BURLINGTON DEVELOPMENT REVIEW BOARD Tuesday December 19th, 2017, 5:00 PM Contois Auditorium, City Hall, 149 Church St, Burlington, VT AGENDA

TO: Development Review Board
FROM: Scott Gustin
DATE: December 19, 2017
RE: 18-0503CA; 92 Appletree Point Rd

Request: Request for amendment of zoning permit 17-0623CA/MA; Revisions to Building C and immediate site vicinity. Overall reduction of 50 parking spaces. No change in overall dwelling unit count (739).

Existing perspective from Bradley Street. Google image 2017.

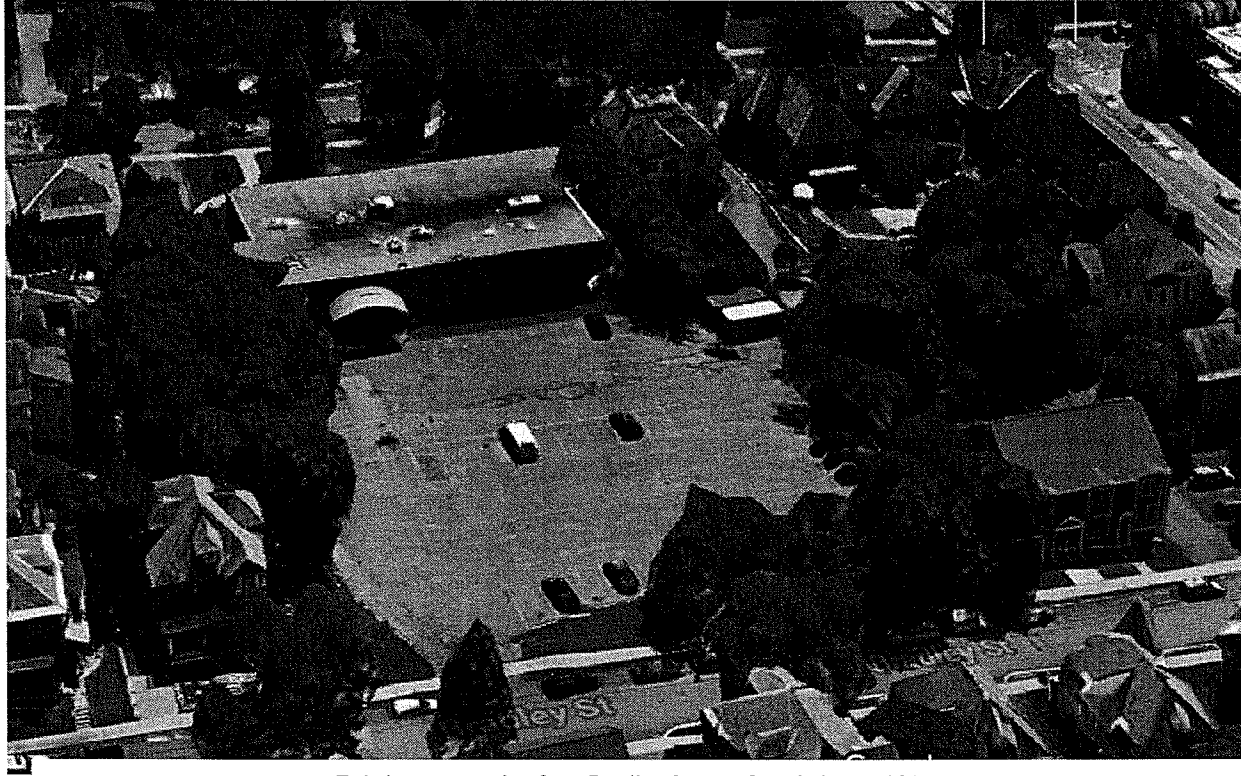
The retaining wall with wooden guardrail proposed for the north street front of the lot has a preliminary estimate of 99' linear feet along Bradley Street with a height up to 8.' With no principle structure to fill in the street wall, the plan threatens to deaden the pedestrian experience with parking and sheds along the streetfront. The accessory uses (parking, storage) have secured a position in a place of prominence and visibility, treating it as a back yard rather than a street frontage. Plainly, the plan turns its back on Bradley Street, contrary to this standard.

The goal of the ordinance is providing a substantive principle building along the Bradley Street frontage in order to occupy the gap in the building rhythm created by the parking lot. This can be achieved a couple of ways: Expansion of the new building or a second building through a Planned Unit Development where more than one principle building occupies the lot. (RH has no minimum project size).

Accessory structures should be placed in a less visible location; deferential to the principal structure or use. A second building, fronting Bradley Street would satisfy strengthening both street walls with new development, which may include these accessory uses.
